Support Bulletin-SB-25-10040

Title: 208-06-6503Y1 & Y2 Missing Wires in Sections 1-6 Connector

Product Line: FAS

Current Pinout of 208-06-6503Y1 & Y2  
(Pin E,F,G not populated)

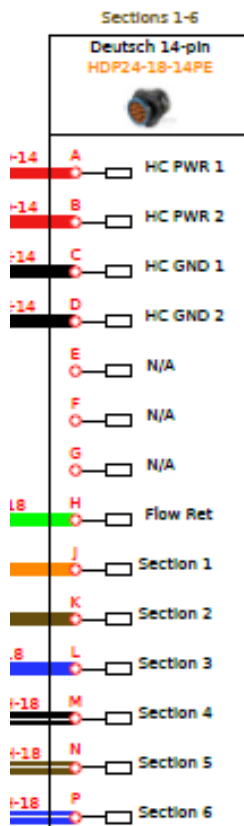
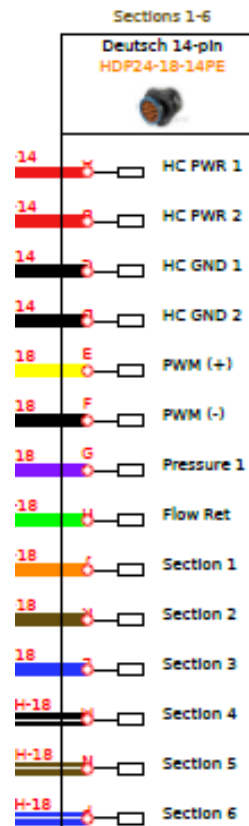
Overview: Sentinel 1000 ECU adapter 208-06-6503Y1 & 208-06-6503Y2 - the Sections 1-6 connector is missing a wire for pressure 1 (pin G), PWM (+) (pin E), and PWM (-) (pin F). If the customer hooks a pressure sensor to the section harness connected to Sections 1-6 the pressure will not read on Sentinel. This harness will also not control a Gen2 LiquiShift valve stack when hooking to Sections 1-6 because all 3 missing wires are required to control the valve stack.

Updated harness 208-06-6503Y3  
(Pins E, F, G are now populated correctly)

There are 3 solutions to fix this issue. The solution used will depend on customer preference and will be covered by SurePoint under warranty.

1. Add a pressure tap on the outlet side of the flowmeter close to the pump system. Plug their sensor into the PRESSURE plug on the pump final harness. The pump harness is pinned out correctly and this will allow pressure to read on Sentinel.
2. Run a 3-Pin Metri-Pack extension from the PRESSURE plug on the pump final harness to their pressure sensor. The pressure sensor will probably be mounted on the end of the section valve stack, so you'll need them to measure how far away the PRESSURE connector is from the pressure sensor to send the right length extension.
3. Replace their existing 208-06-6503Y1 or 208-06-6503Y2 with the updated harness 208-06-6503Y3. This HAS TO BE DONE on all systems using the 208-06-6503Y1 or Y2 with a Gen2 LiquiShift valve stack.

If you replace any harness in the field with the new Y3 version you must have Sentinel Software version 1.6.0 or newer installed for the harness to work properly. There are new modifications to this Y3 version that require our newest software. When the Y3 is plugged into Sentinel you will see Harness Ident: 1 on the software page like the image below. This will allow your pressure sensor to work when plugged into Sections 1-6 as well as control the Gen2 LiquiShift valve stack.
